Access Compliance Report

Public Rights-of-Way

(Curb Ramps)

Intersection ID: 3901	Main Street: RHIAN_BROOK_LN	Cross Street: BEATTIES_FORD_RD	Location: NW
ADA ID: 21F51D1823AD	Ramp Type: BlendTrans1	Initial Pass/Fail: Pass	Overall Compliance: No
Severity Score: 0.25			
Codes/Mitigation Info/Possible Solution		Field Measurements/Component Compliance

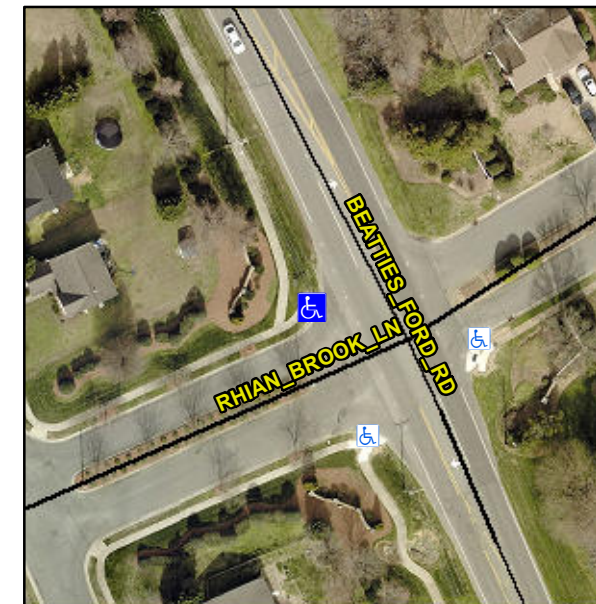
R304.5.3, R304.2.1

Compliance	Description	Data	Compliance	Description	Data
N/A	Ramp Length (in)	48.0	Yes	BlendTrans Slope (%)	2.1
Yes	Ramp Width (in)	49.0	No	BlendTrans XSlope (%)	4.6
N/A	Flare Type LT	Sloped	N/A	Flare Type RT	Sloped
N/A	Flare Slope LT (%)	3.1	N/A	Flare Slope RT (%)	0.3
N/A	Flare Traversable LT?	No	N/A	Flare Traversable RT?	No
No	Landing Length (in)	47.0	Yes	DWS Provided?	Yes
Yes	Landing Width (in)	48.0	Yes	DWS Contrast?	Yes
Yes	Landing Slope (%)	0.8	Yes	DWS Length (in)	24.0
Yes	Landing X Slope (%)	1.9	Yes	DWS Full Width?	Yes
N/A	Landing Curb? (Y/N)	No	Yes	DWS Offset (in)	0.0
N/A	Shared Landing?	No			
Yes	Gutter Ponding?	No	Yes	Gutter Slope (%)	1.5
Yes	Gutter Lip Ht (in)	0.0	Yes	Gutter X Slope (%)	0.8
N/A	Painted X Walk1?	No	N/A	Painted X Walk2?	No
	X Walk 1 Direction	To SE		X Walk 2 Direction	To NE
	X Walk 1 Width (in)	N/A		X Walk 2 Width (in)	N/A
	X Walk 1 Slope (%)	0.1		X Walk 2 Slope (%)	1.6
	X Walk 1 X Slope (%)	1.9		X Walk 2 X Slope (%)	0.2

Remove & Replace Curb Ramp With Two New Directional Ramps or Equivalent.
